TOWN OF MILTON  
PLANNING AND DEVELOPMENT  
BUILDING PERMIT: 17-7103  
BUILDING: REVIEWED  
SCOTT SHERRIFFS JUN 12, 2017  
PLANS EXAMINER DATE  
Neither the issuance of a permit nor carrying out of  
inspections by the Town of Milton relieves the owner from  
full responsibility for compliance with the provisions of  
the Ontario Building Code Act and the Ontario Building  
Code, both as amended, as well as other applicable  
statutes and regulations of the Province of Ontario,  
By-laws of the Region of Halton and Town of Milton

JUNIPER 9-317  
ENERGY STAR

Greenpark.  
PROJECT NAME  
LECCO RIDGE

### BASEMENT FLOOR PLAN '2'

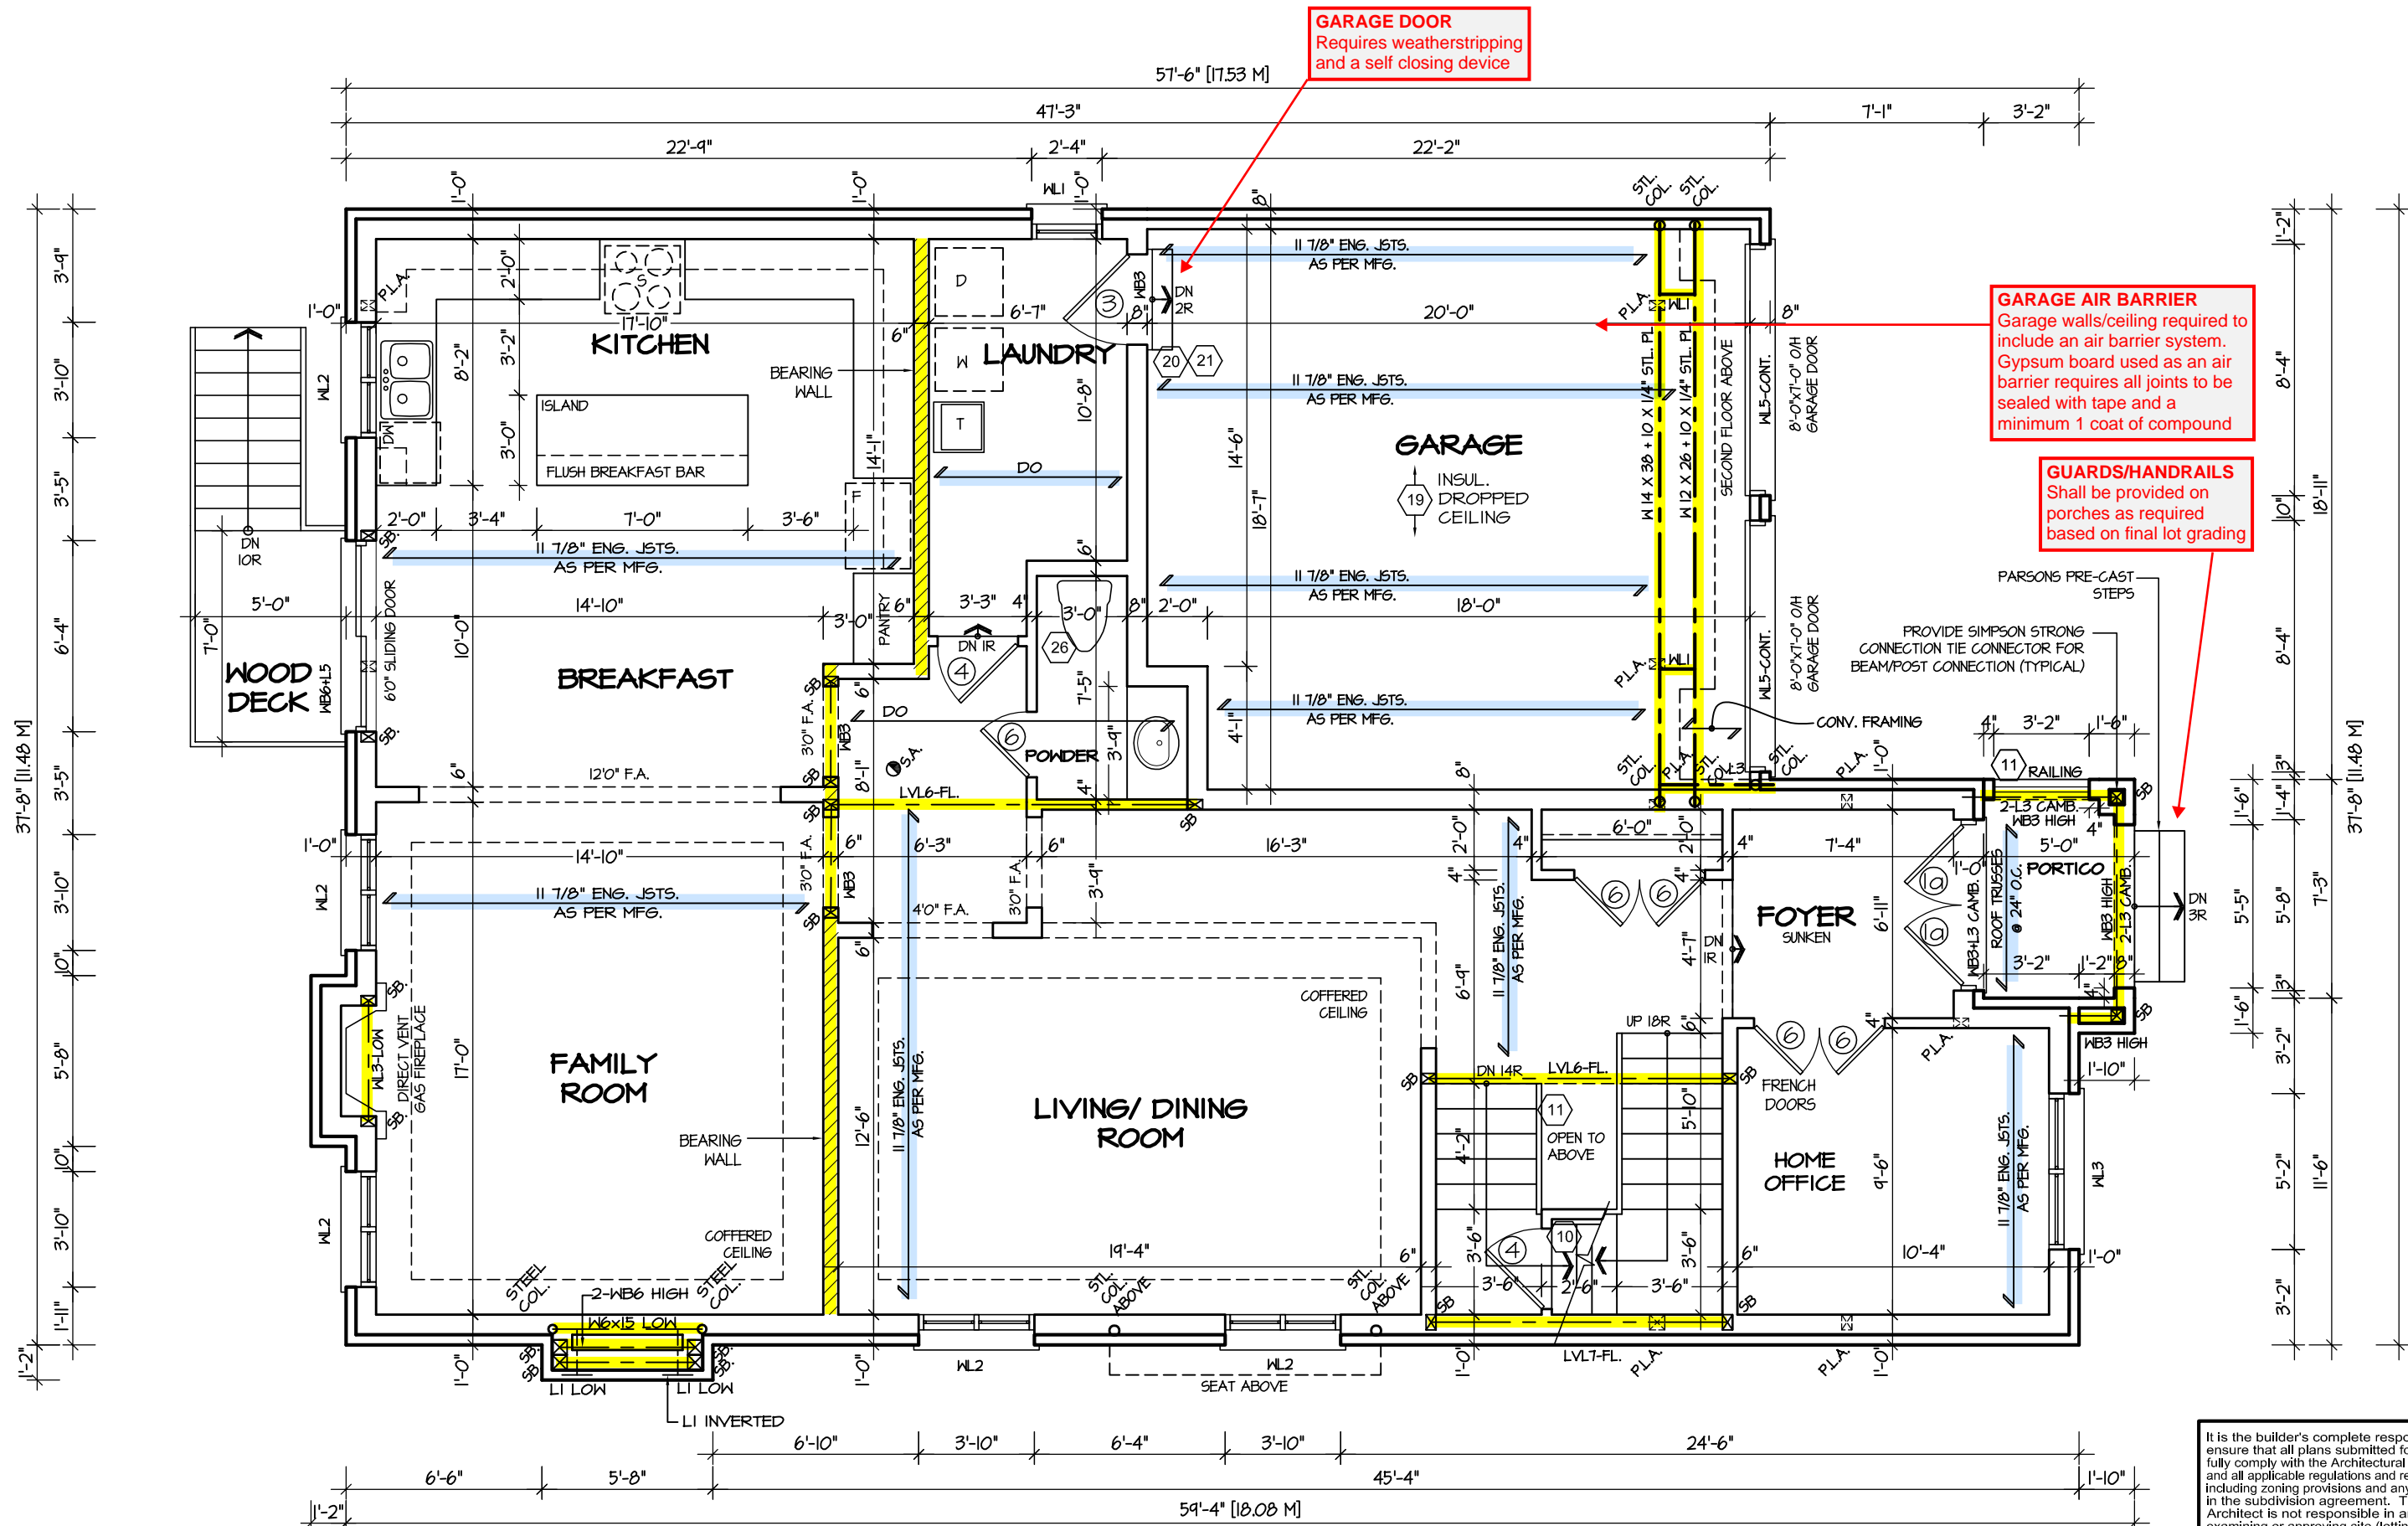
**UNSUPPORTED FOUNDATION**  
Foundation wall laterally unsupported below window open. Provide reinforcement as specified in detail B1 (Page No 0)

SECOND FLOOR PLAN '2'

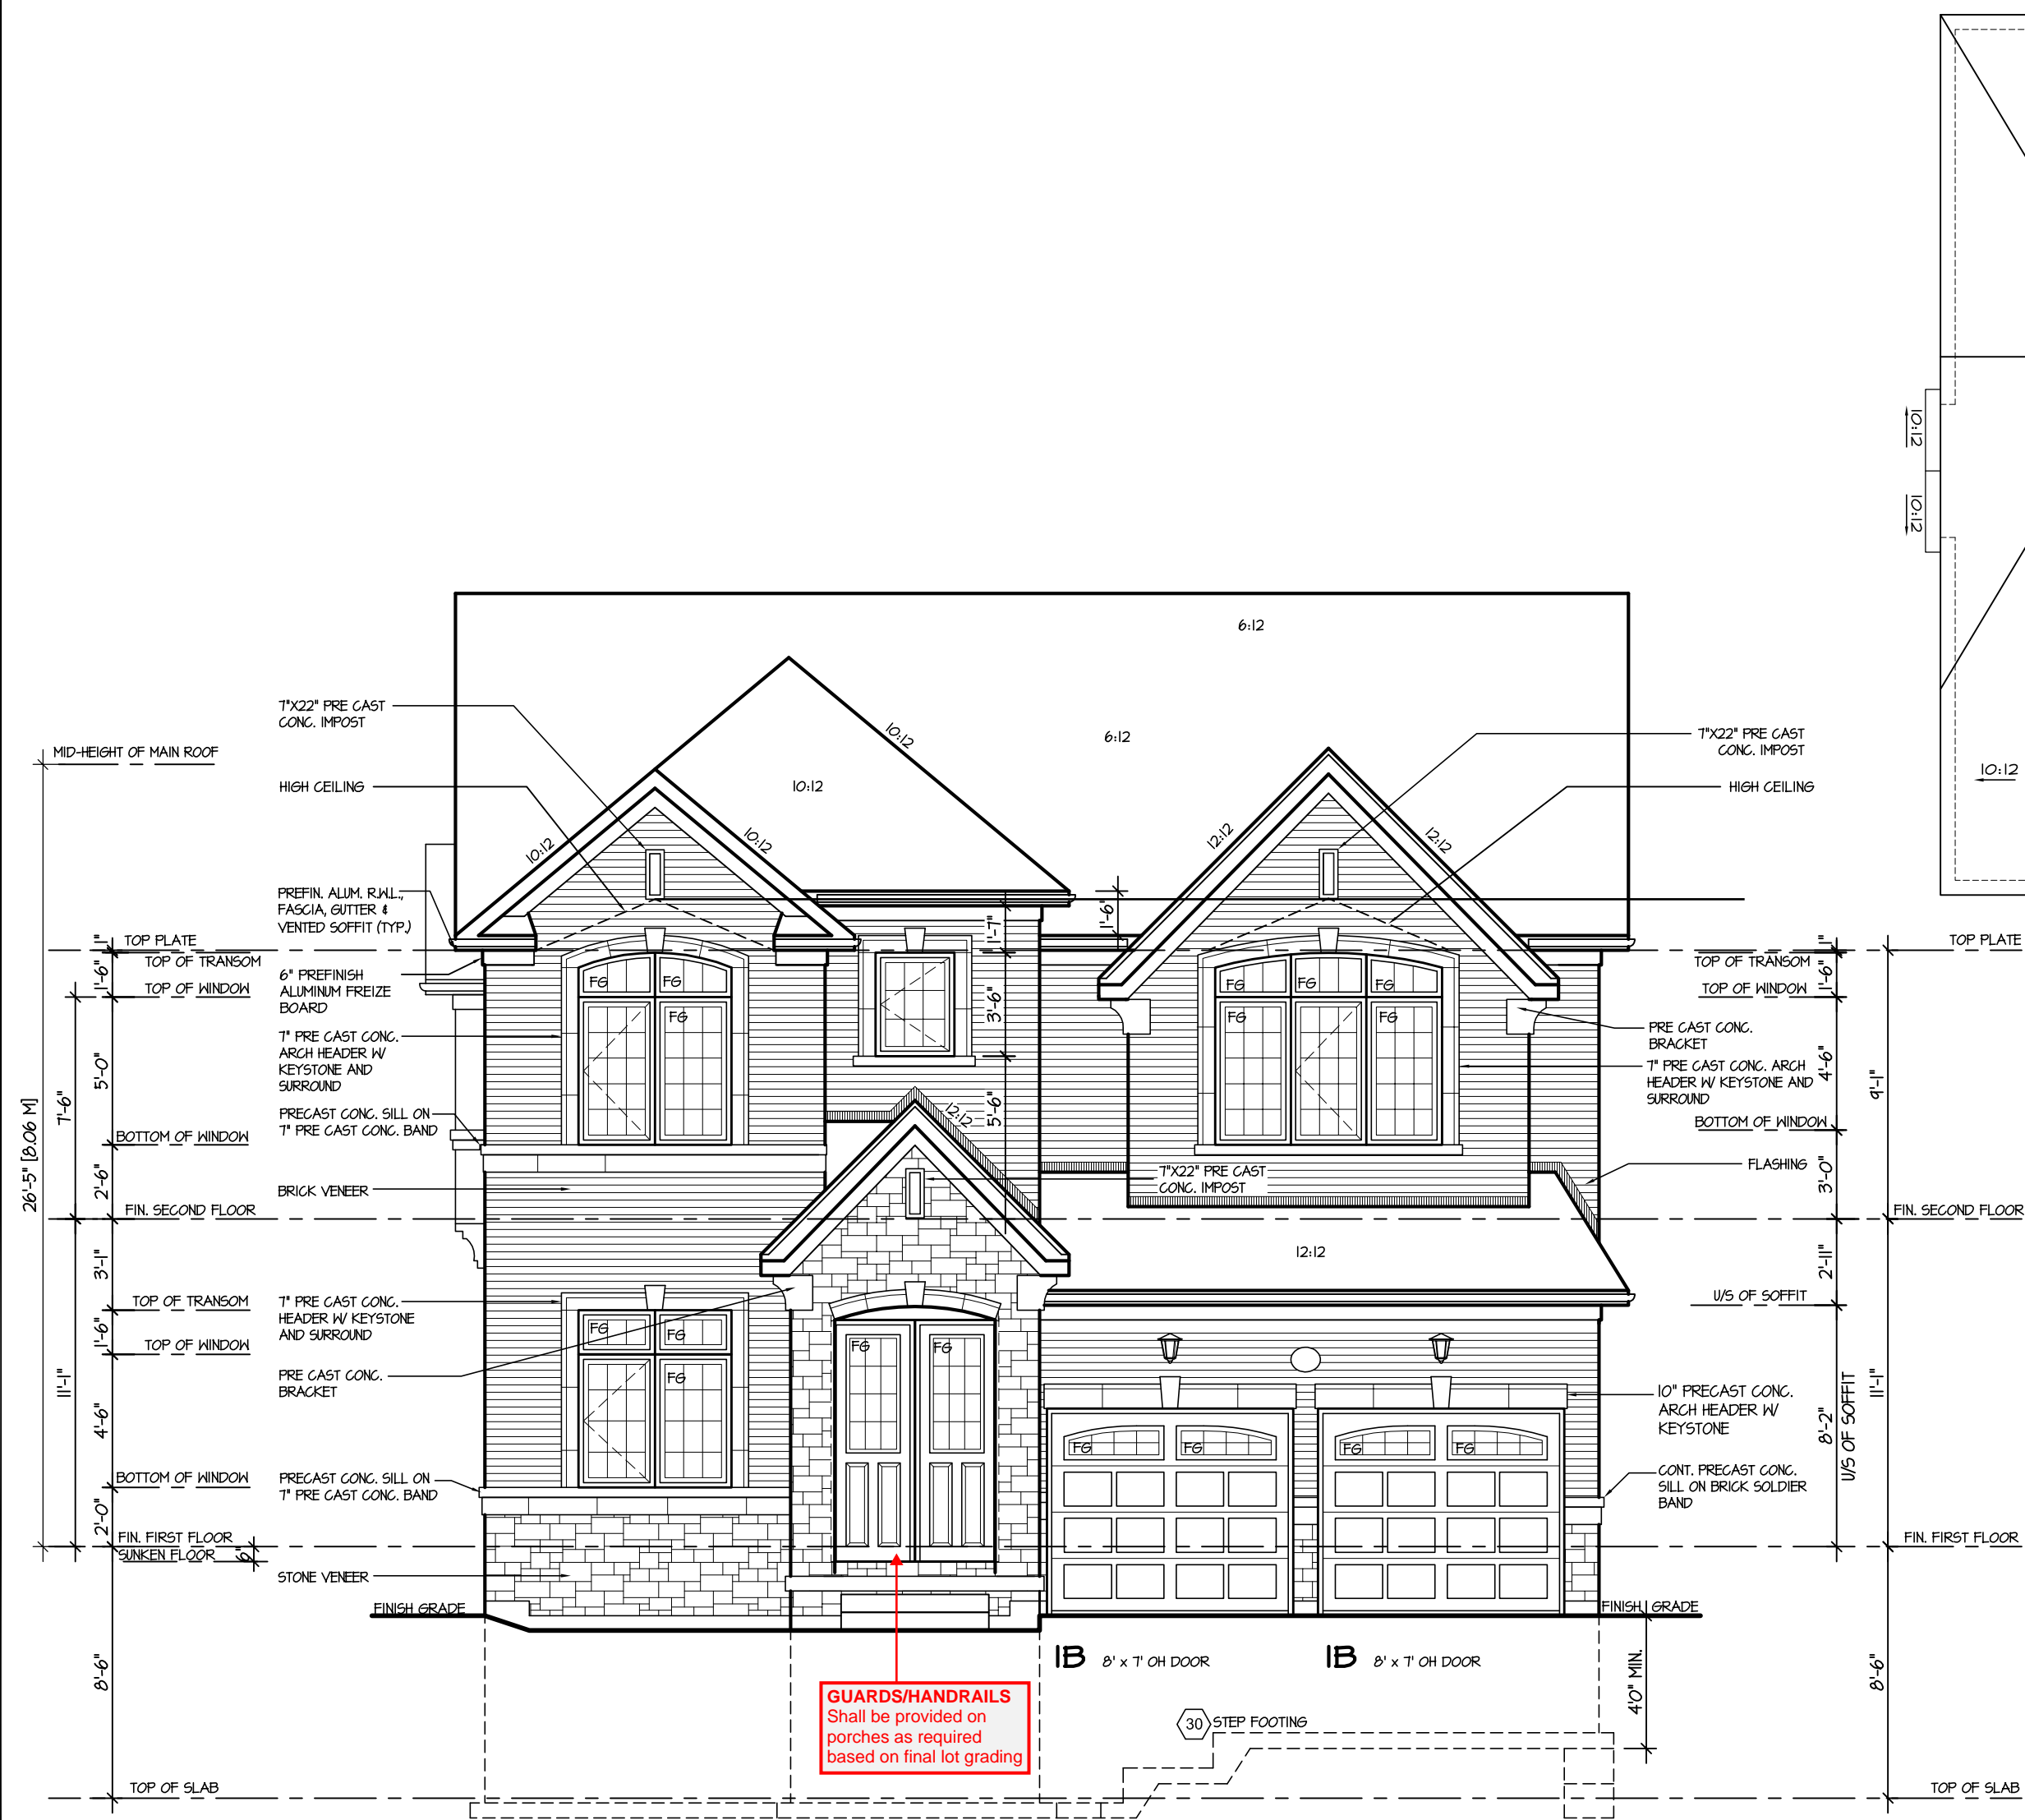
**BATHROOM BLOCKING**  
See standard details page 8  
for required main bathroom  
grab bar reinforcing

REAR ELEVATION 2

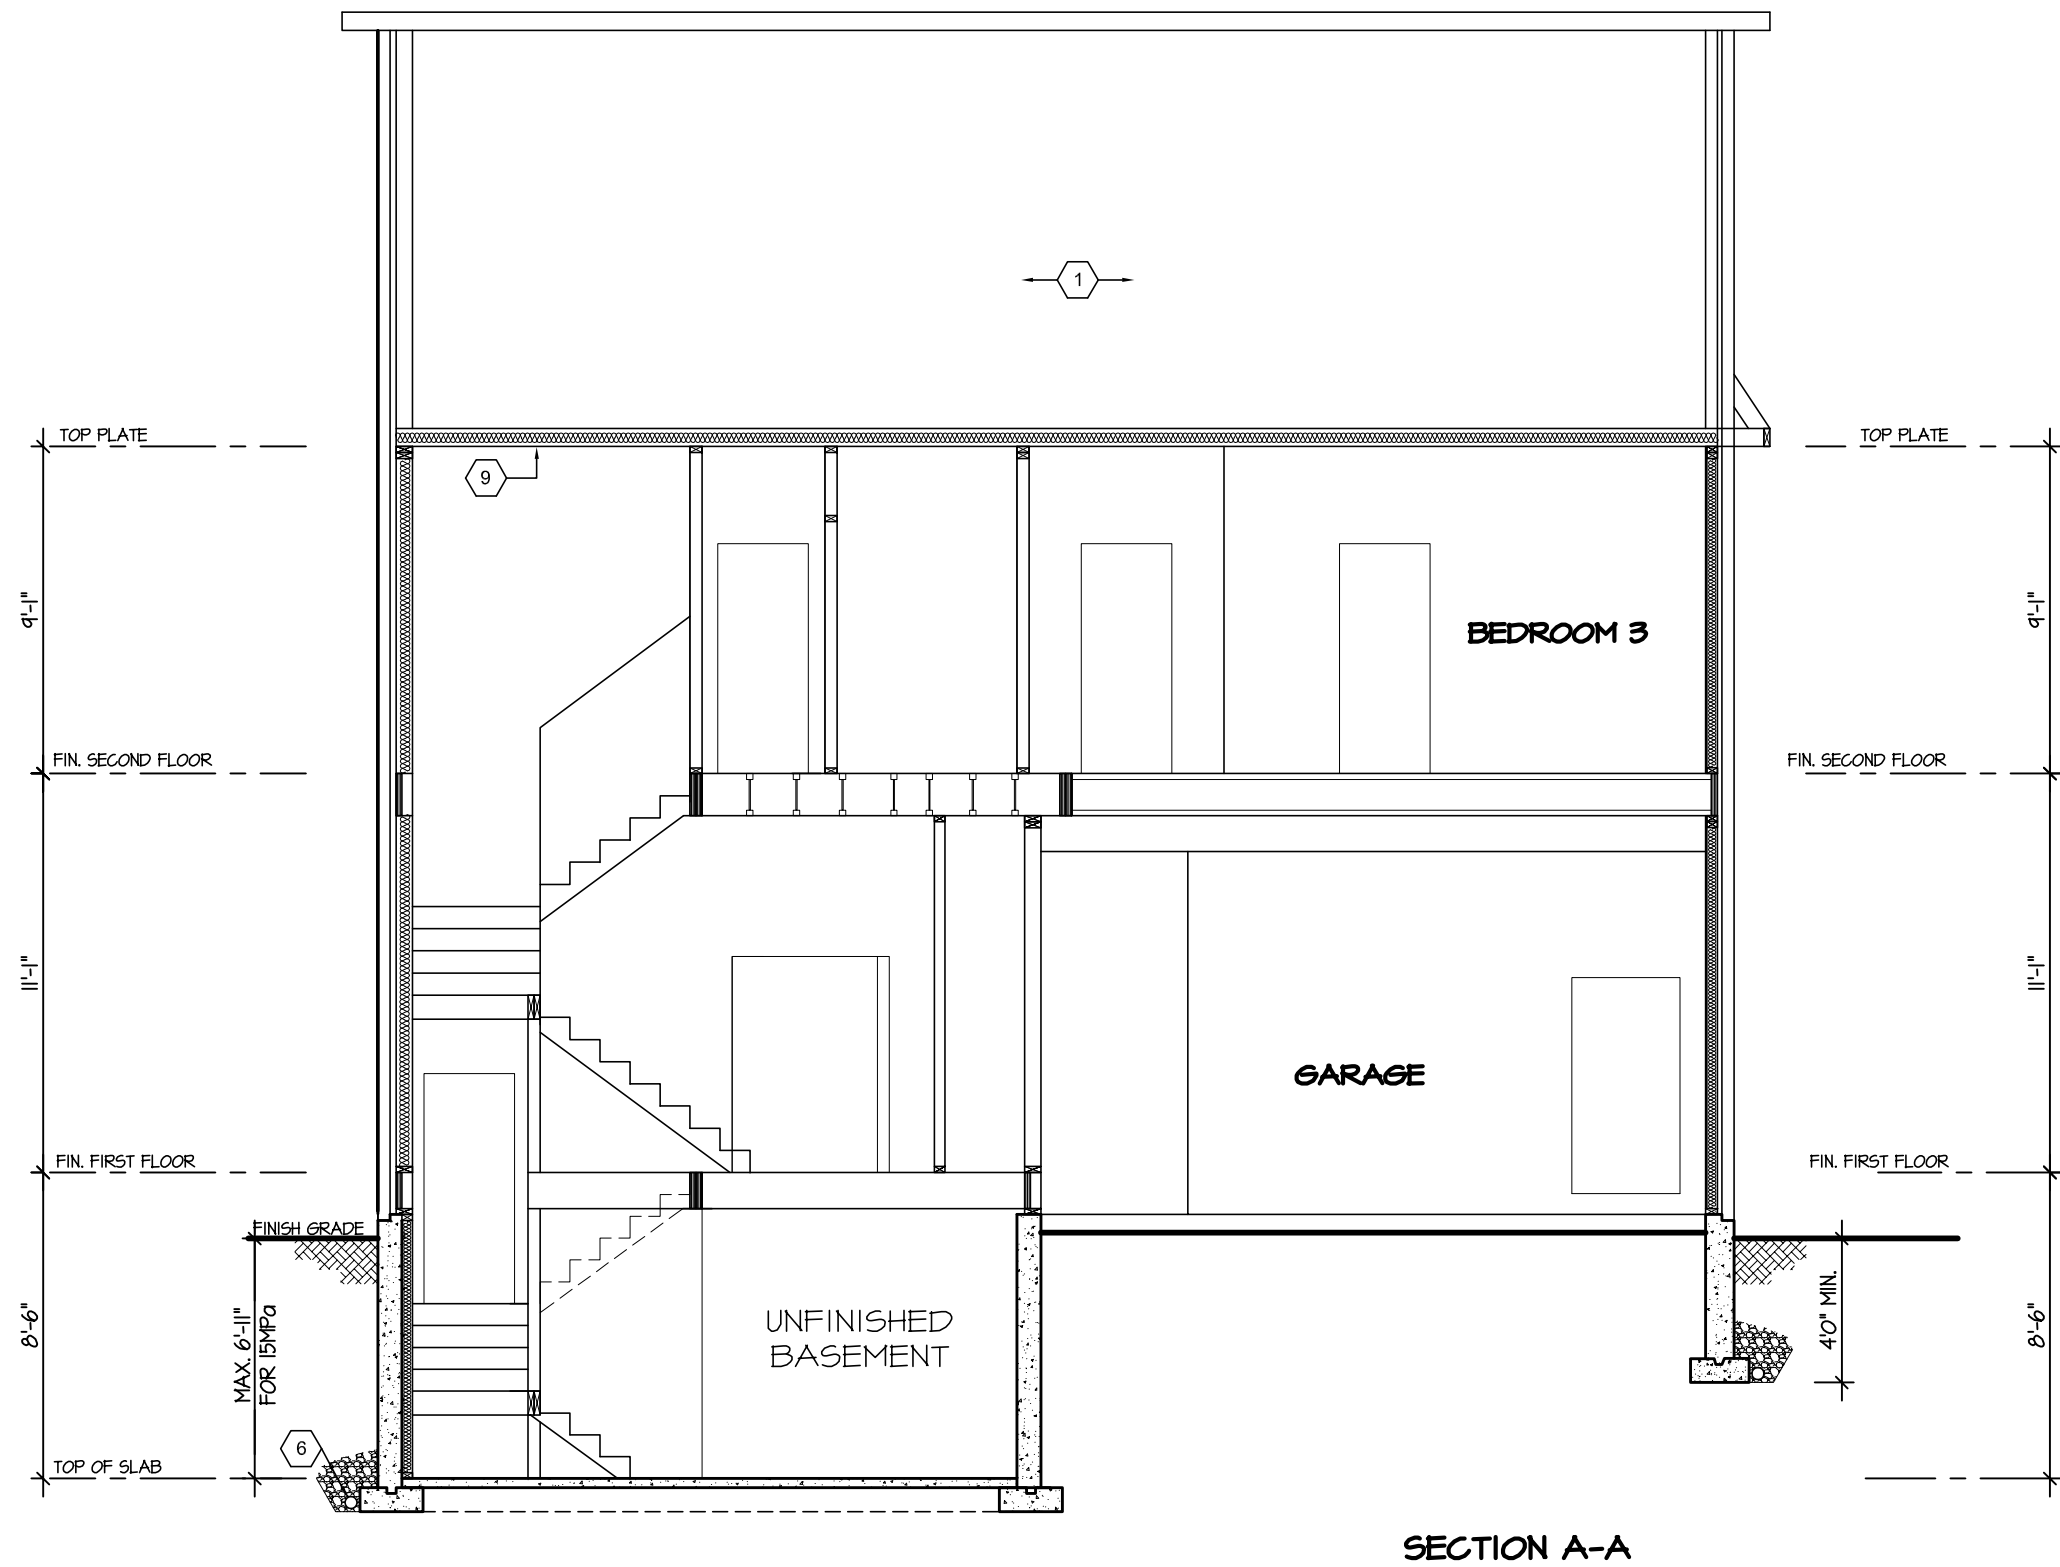
DECK DETAILS  
See standard details pages 5  
and 5-2 for additional deck  
construction details
